DESIGN GUIDELINE PRIORITIES

QUEEN ANNE DESIGN REVIEW BOARD

Meeting Date: July 2, 2008

Project Number: 3009234

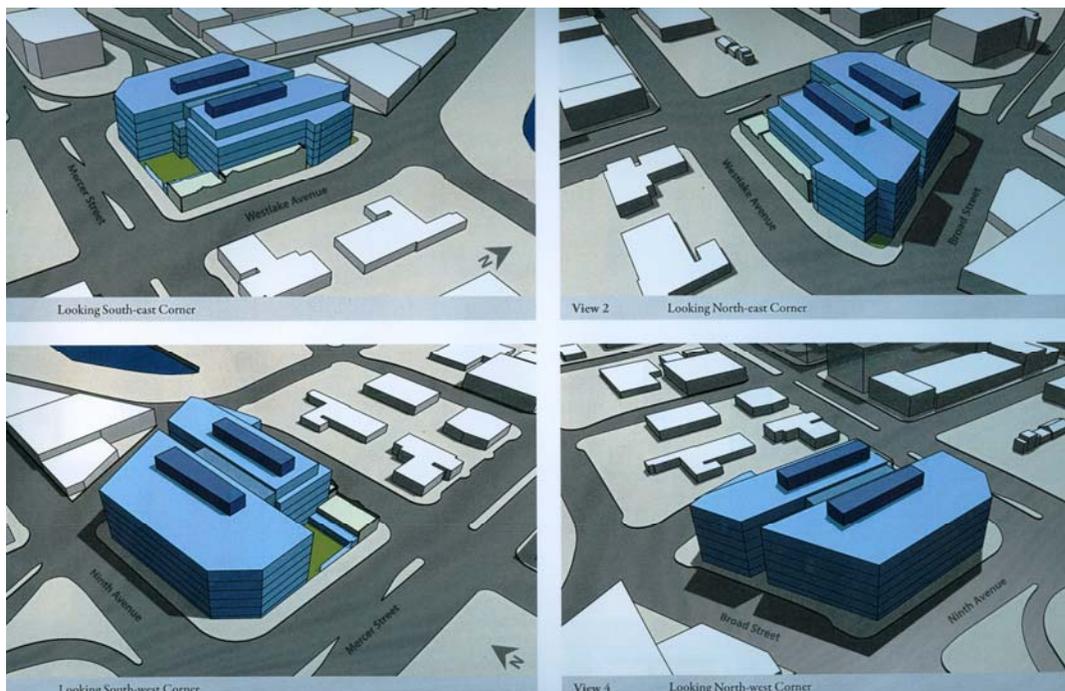
Public comment was received. The Board was urged to address the historic building context in their comments and in the building massing favored. It was stated that the proposal appeared to be too massive as viewed from 9th Ave. There could be two articulations of the building on 9th, similar to the duality of expression in other areas of the proposed massing. Those public members present seemed most interested in the success of the historic preservation aspects of the proposal.
